FROM:**Boni•Maddison Architects**

TO:**Bidders****PROJECT:****Unicorn Daycare – Trail, BC Project Number 23-06****TENDER ADDENDUM #2**

This Addendum shall be read in conjunction with and considered as an integral part of the Contract Documents for the above project; revisions supersede the information contained in the original drawings, specifications or previously issued Addendum.

DRAWN: AB/RB **D1.15**

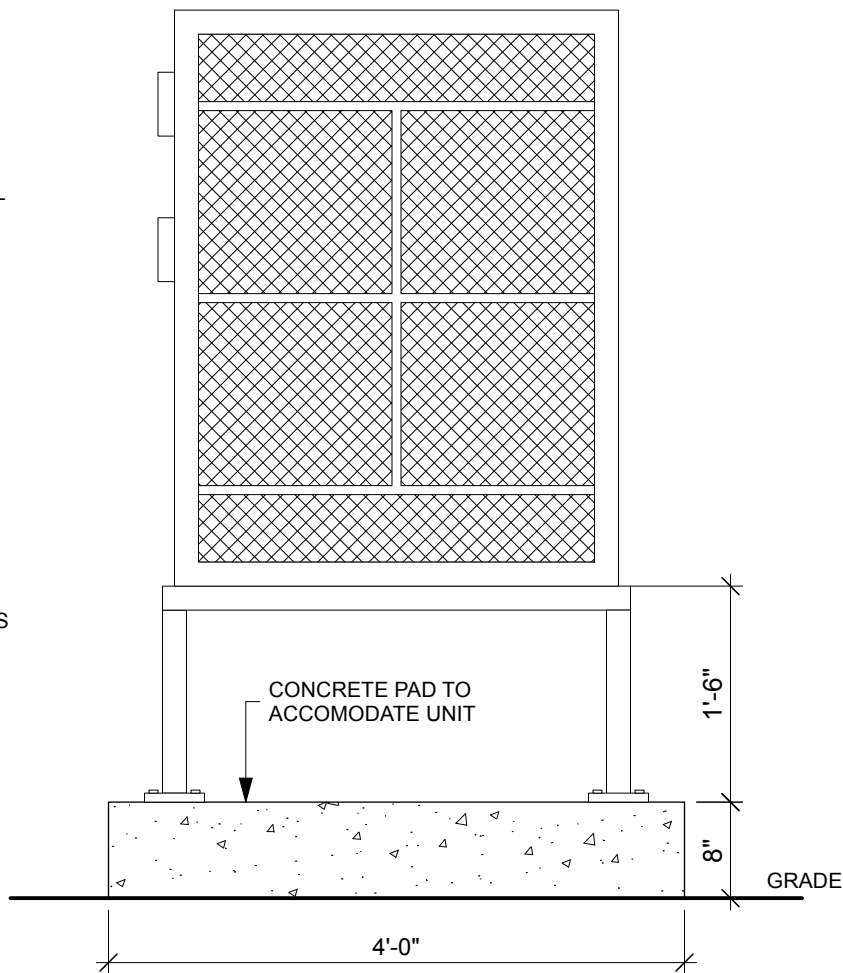
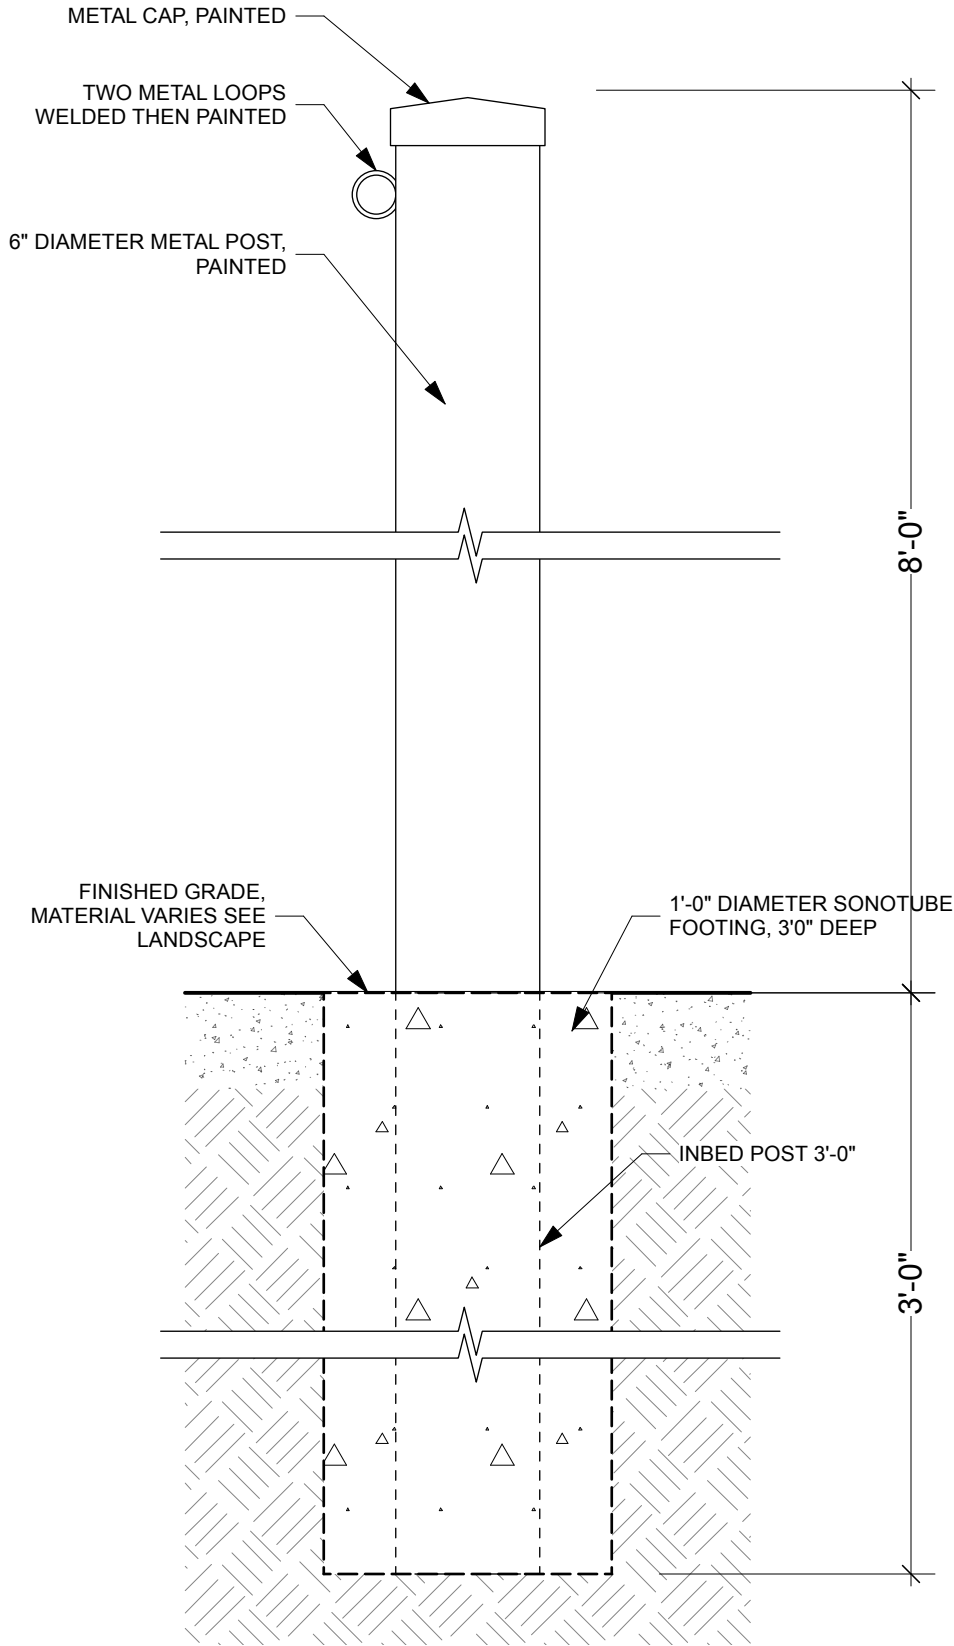
1. D1.15 REVISE: Detail D1.15 errors on drawing sheet, see attached.
2. D1.16 ADD: Detail D1.16 for post in landscape, see attached.
3. D3.03 & D4.14 DELETE: resilient channels on walls of Nap Rooms 112 & 117.

TITLE:
HEAT PUMP @ GRADE DETAIL

DRAWN: SCALE: AS NOTED
JOB N°: 23-06
DATE: 2025
DRAWING N°: A9.01
REV. N°:

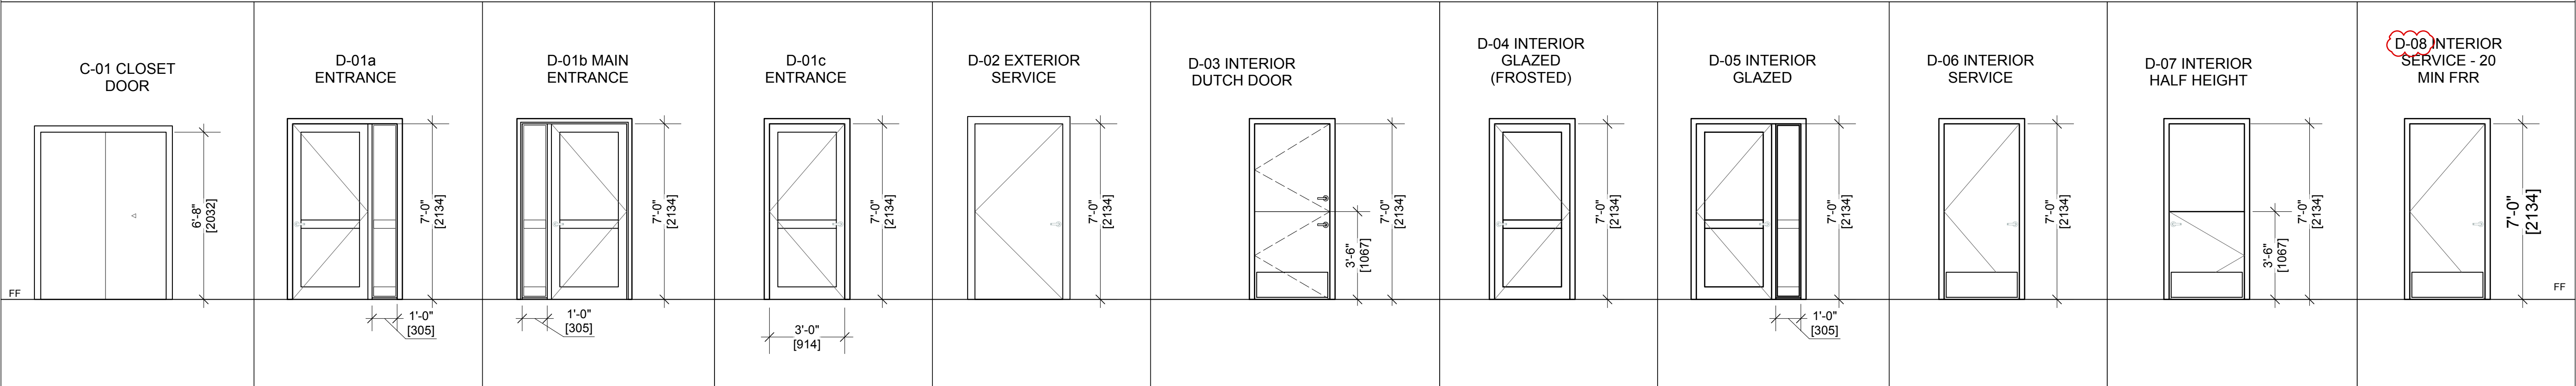
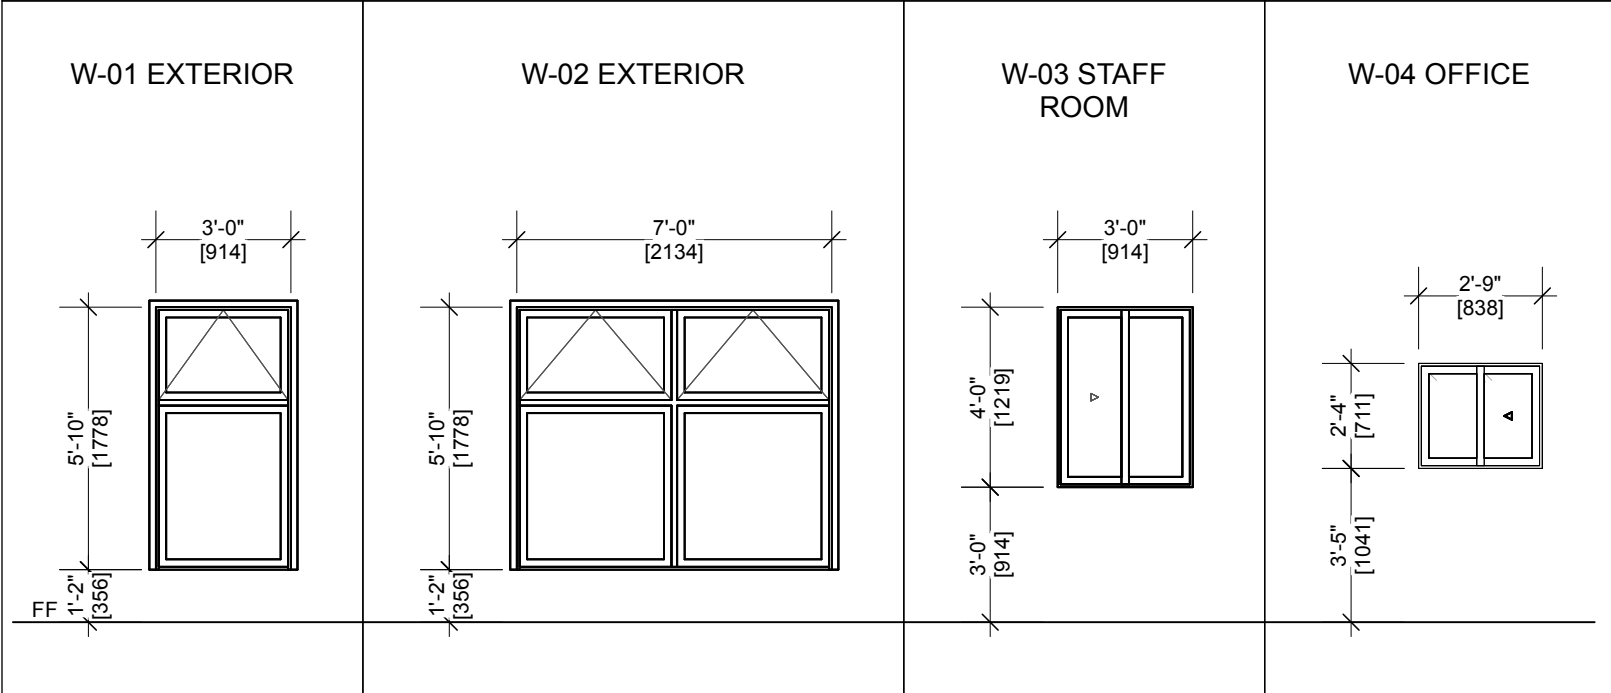
- Architectural specification section 10 50 00 (3)
- Revised Architectural Detail D1.15 (1)
- Architectural Detail D1.16 (1)
- Revised Architectural Drawing A9.01 (1)
- Electrical Addendum E-01 (1)
- Civil Drawing Set (12)
- Civil Memo (1)
- Civil Specifications (1)

HOR. SCALE	1:200	VERT. SCALE	
PROJECT	C26001 - 001		
SHEET	C6	# IN SET	11
ISSUE	D	REV.	1

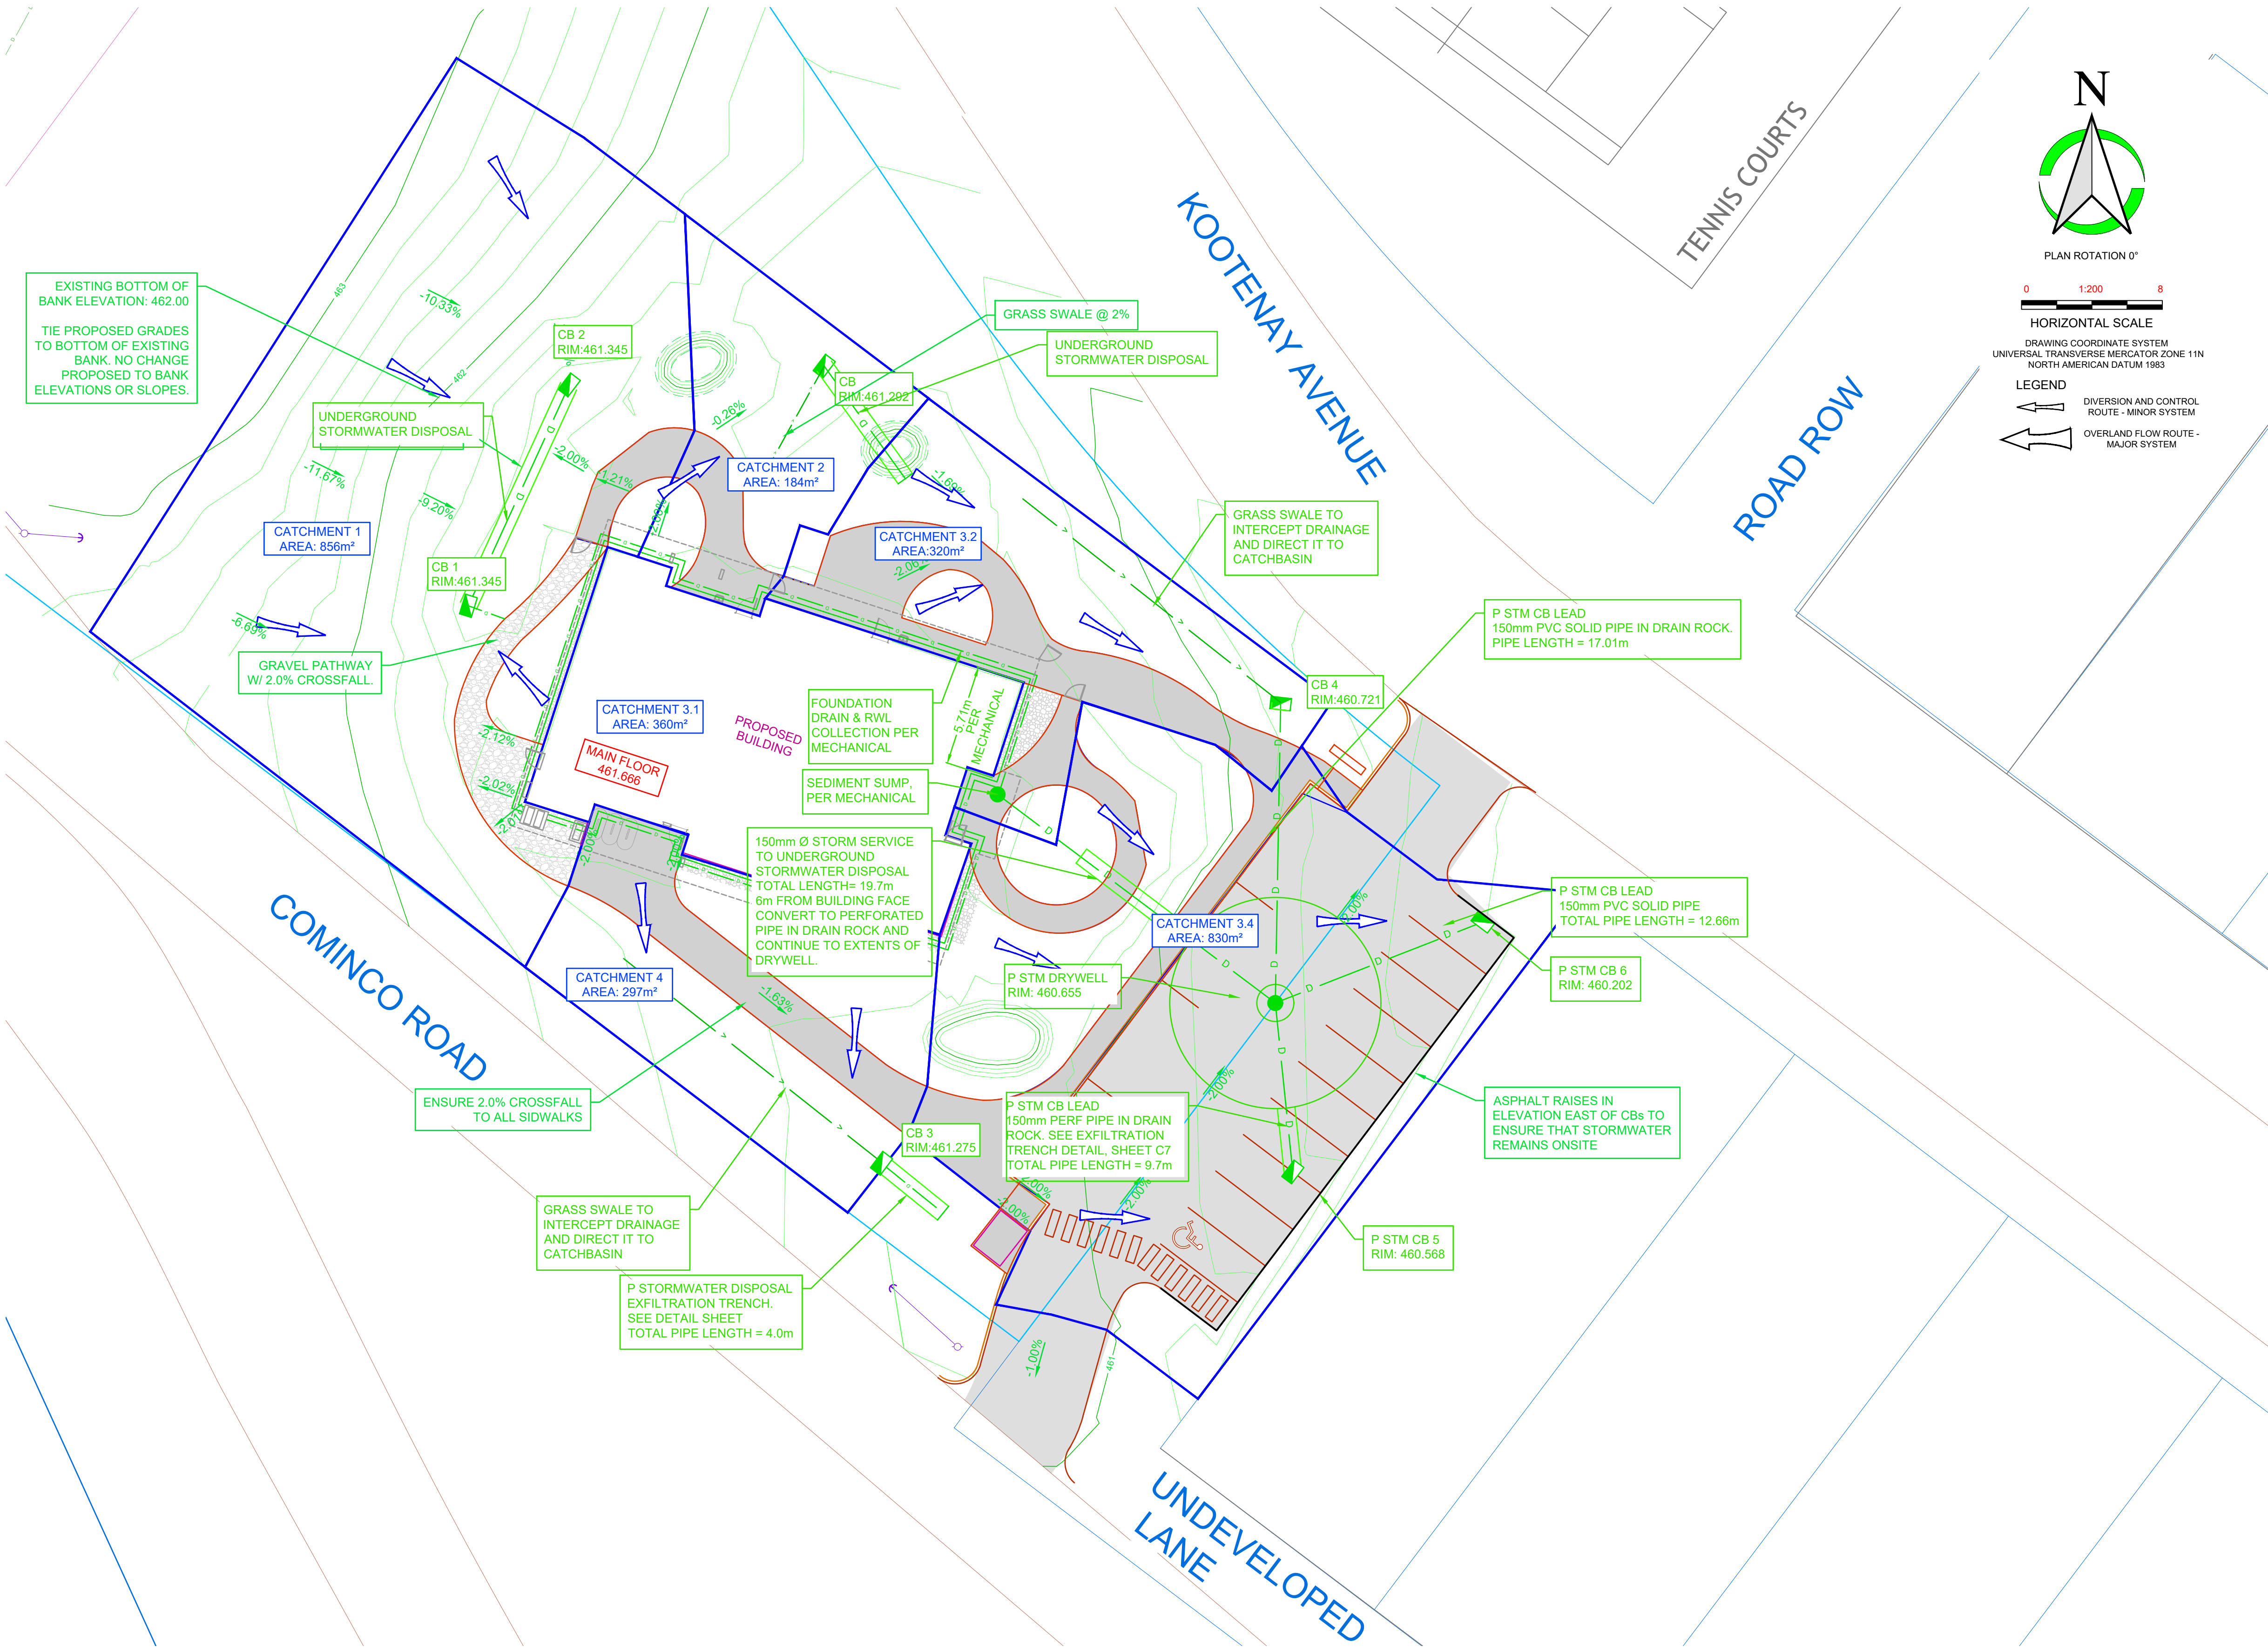
- Perforated Storm Pipes have been corrected to all show a diameter of 150mm (Sheet C7)
- Drywell diameter of excavation base and slope have been revised. (Sheet C7)
- Exfiltration trench detail revised to show a depth of 0.75m (Sheet C7)
- CB3 has been disconnected from the main drywell and now drains to its own exfiltration trench with a linear length of 4.0m. Storm Catchment Numbers and storage areas revised. (Sheet C6)
- Drain rock surrounding the CB leads from CB4 and CB5 has been removed and the leads have been changed to a solid pipe to avoid conflict with potential relocation of irrigation lines. (Sheet C6)
- CB diameter to be 600mm. General Notes on Sheet C4 have been revised to match the detail on Sheet C7.
- Drain Rock Sizes for Drywell and Exfiltration Trenches have been revised to give an acceptable size range for each location. (Sheet C7)
